1906 20TH AVE S
SDCI #3037697-LU
Design Review Board Recommendation Meeting
June 28, 2022

EDG RESPONSE

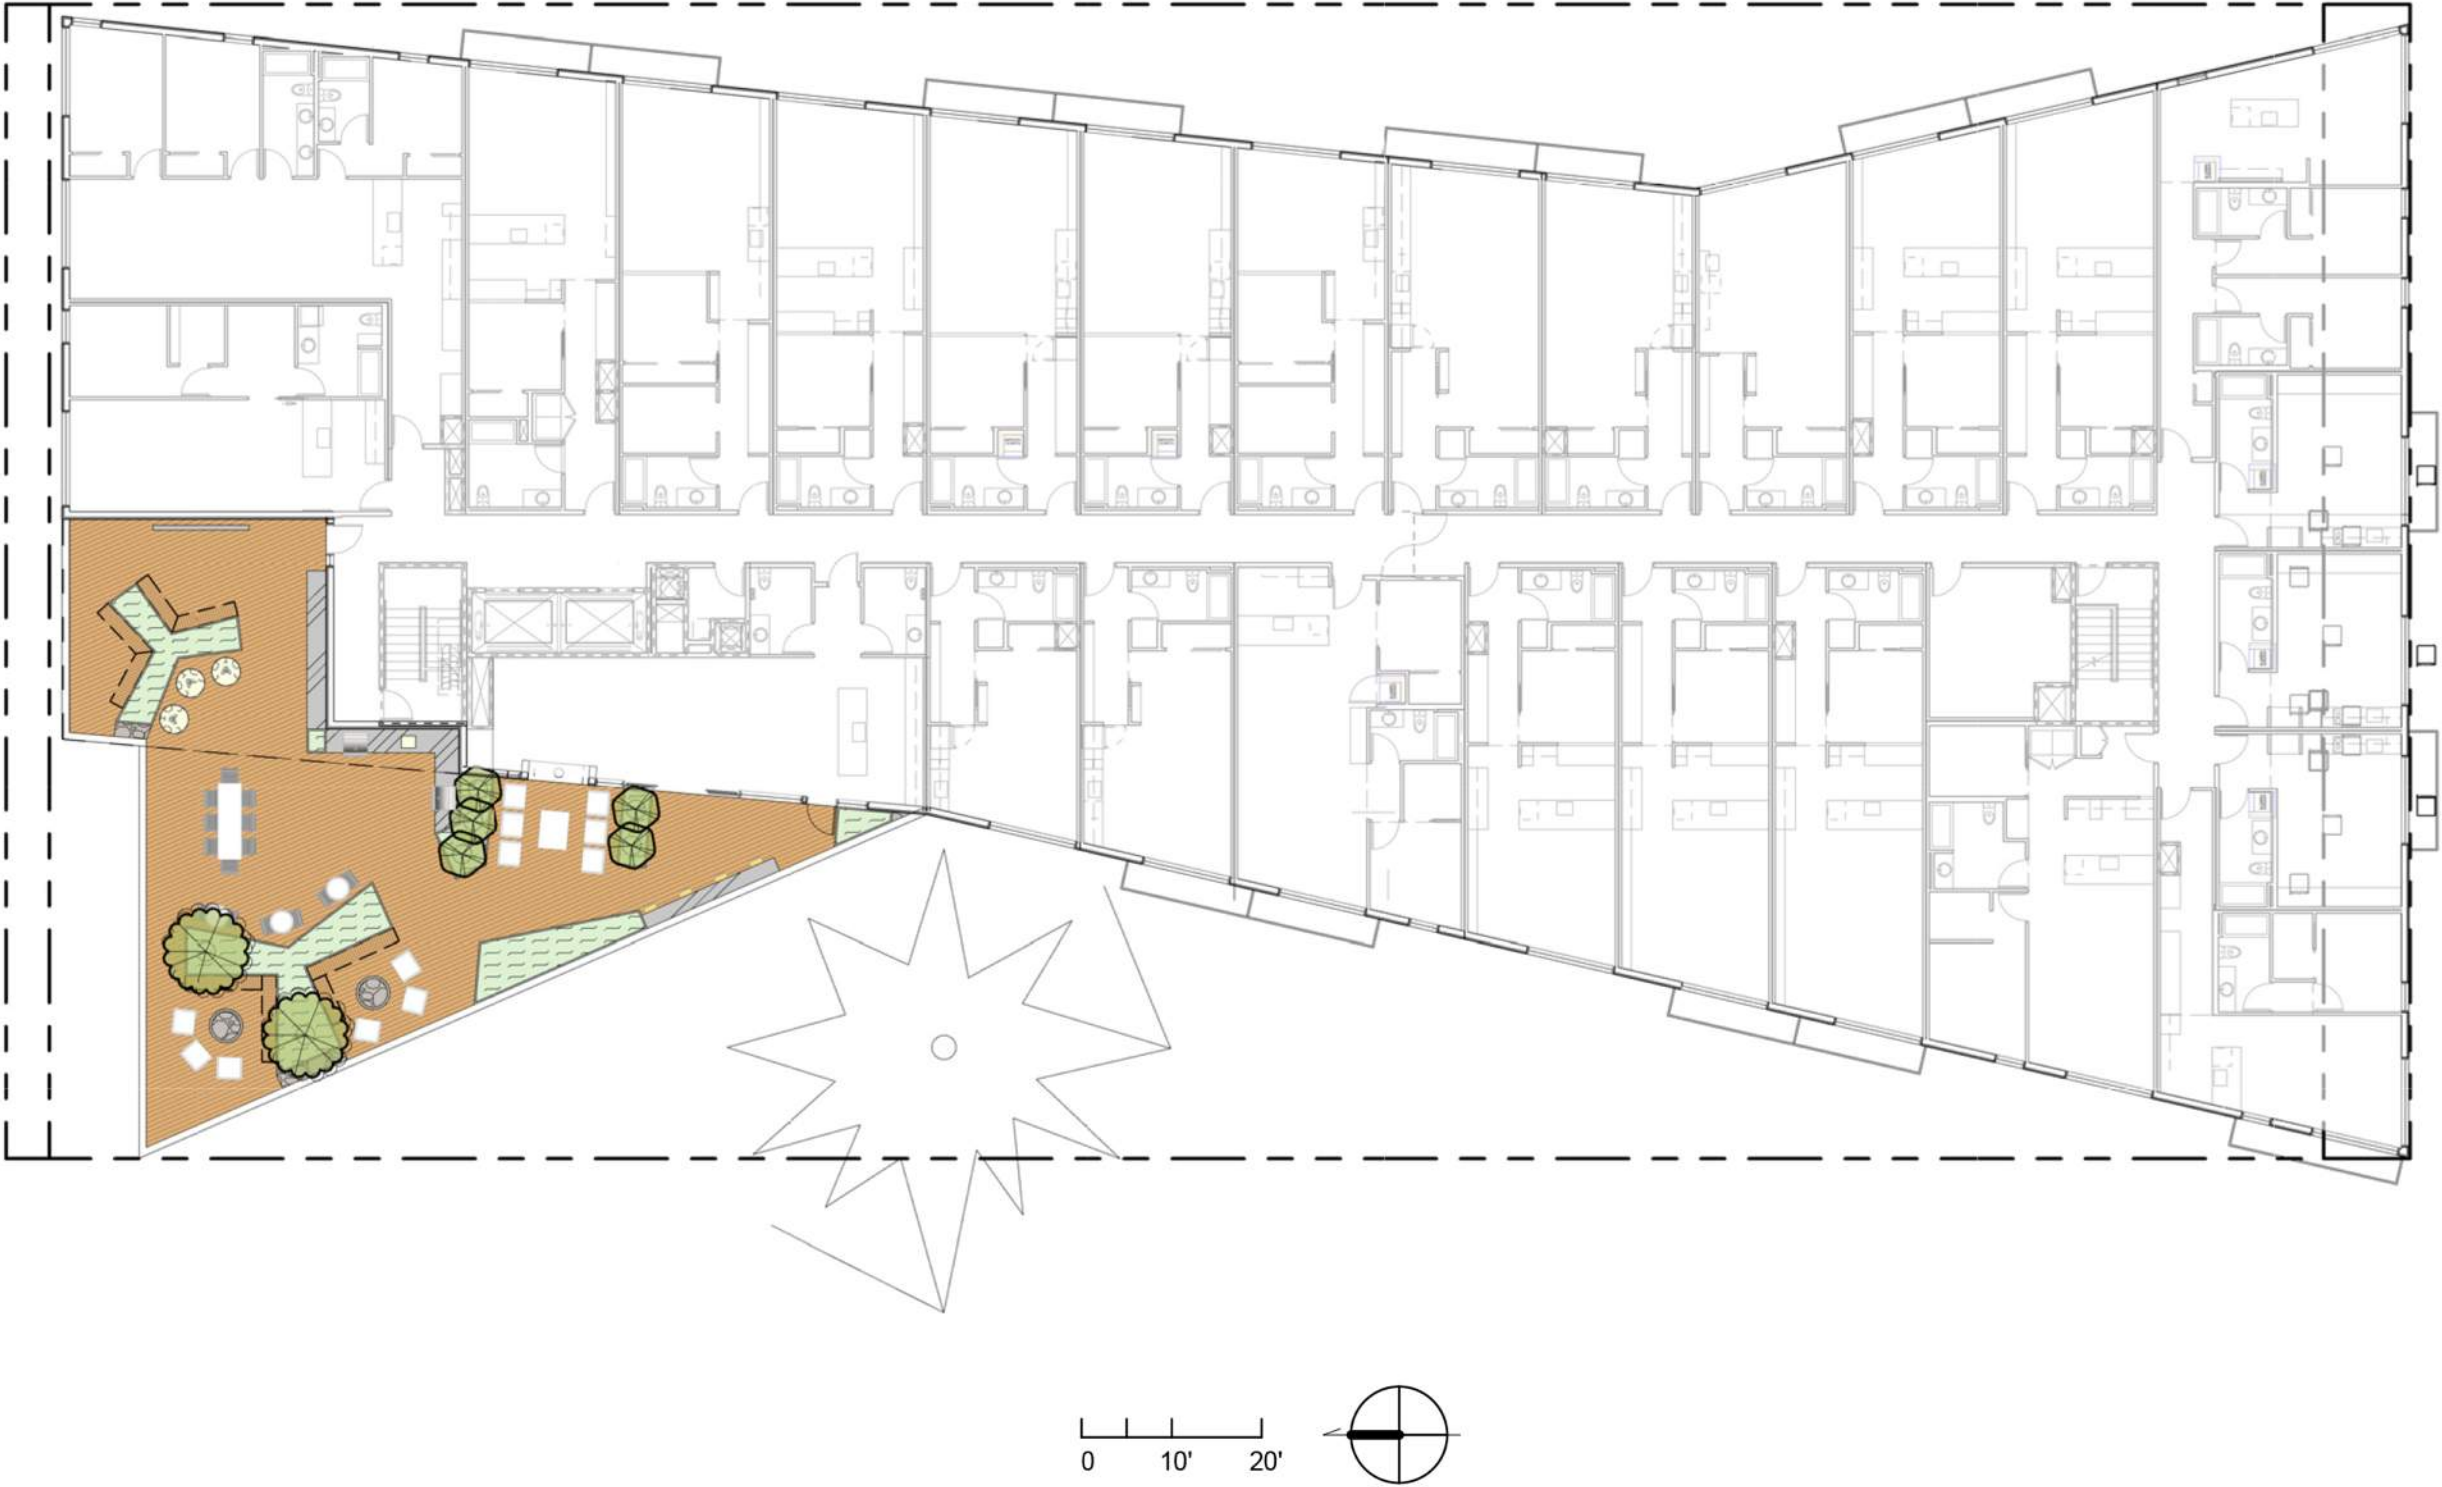
2c. The Board anticipated the potential desire of future residential tenants to use window air-conditioning units and proposed incorporating the ability to do this within the façade design so that *air-conditioning units could be grouped or aligned to be complementary to the building design* (DC4-A-1. Exterior Finish Materials, DC2- B-1. Façade Composition).

2c. Venting will be integrated into the siding coursing for kitchen range hood exhaust and AC is being provided to the units by vertical shafts and rooftop HVAC units, see proposed detail.

SITE LIGHTING CONCEPT

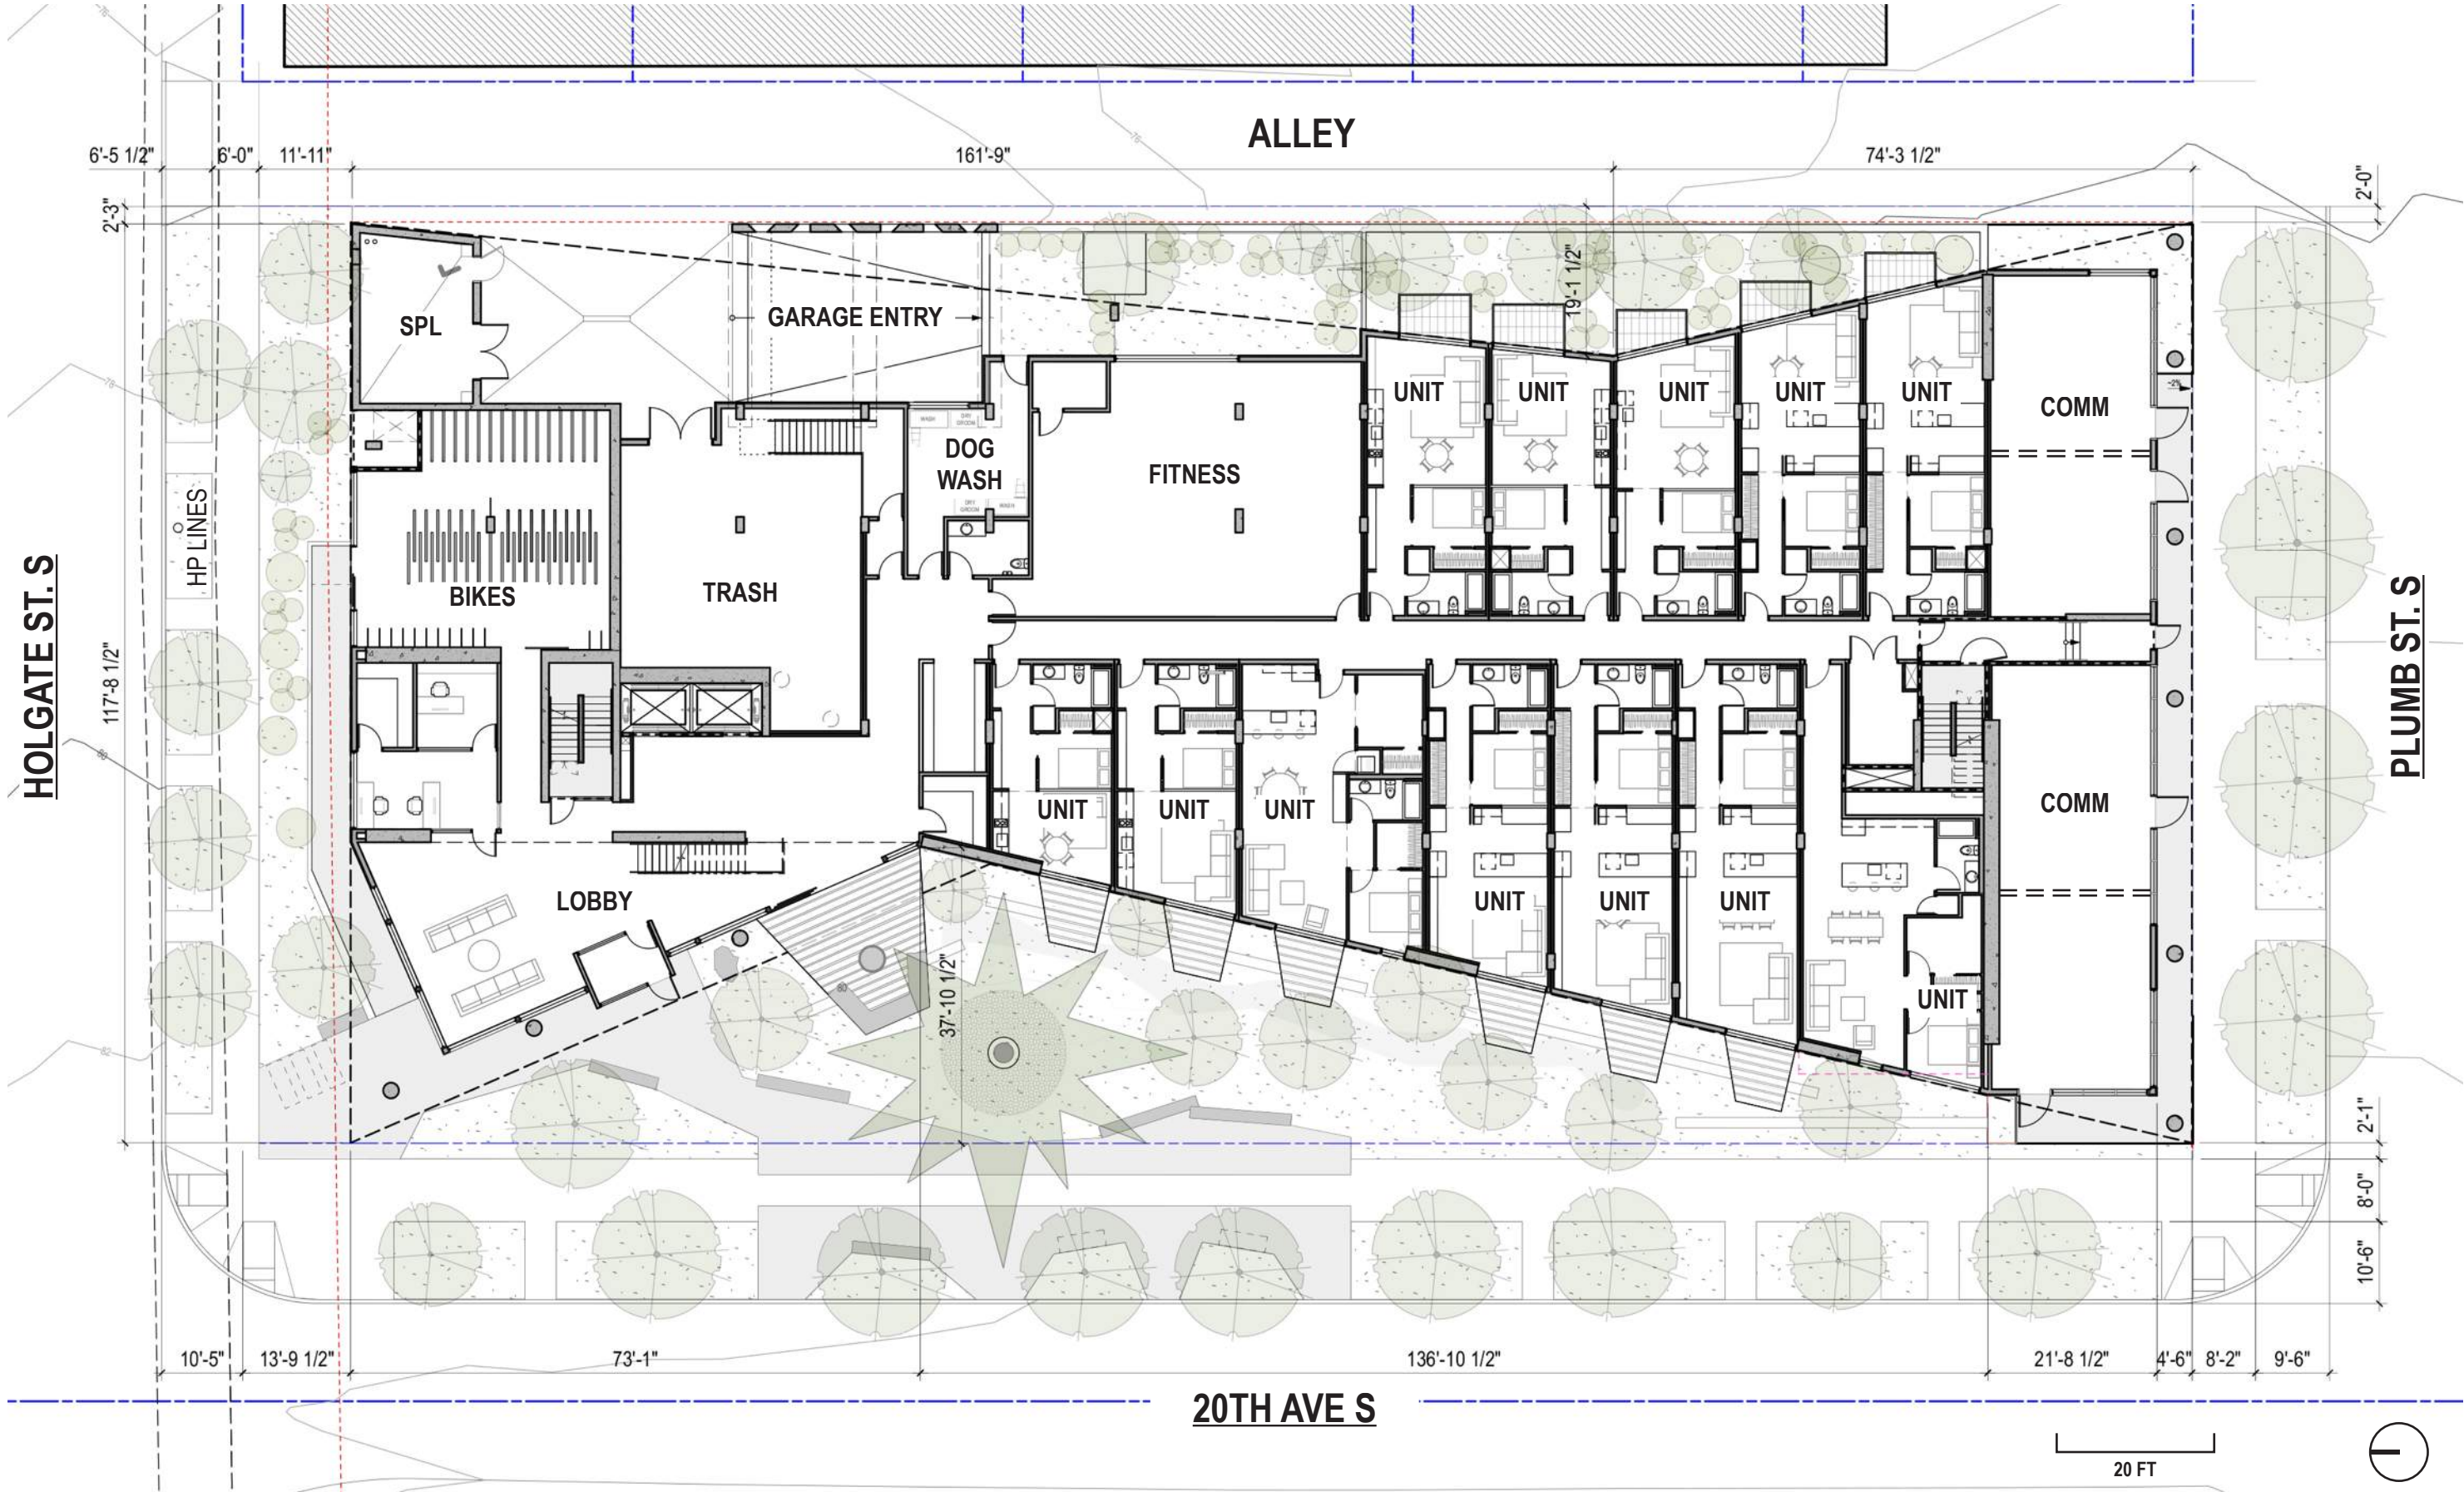
EDG Guidance
3b. The Board requested a lighting diagram at the Recommendation phase of review to show that lighting will be used to augment wayfinding and safety (PL2-B-2. Lighting for Safety, PL3-A-4. Ensemble of Elements, PL3-C-2. Visibility, DC4-C-1. Functions).

Design Response:
3b. Refer to the following lighting diagram showing the lighting augmenting the wayfinding and security of the proposed plan.
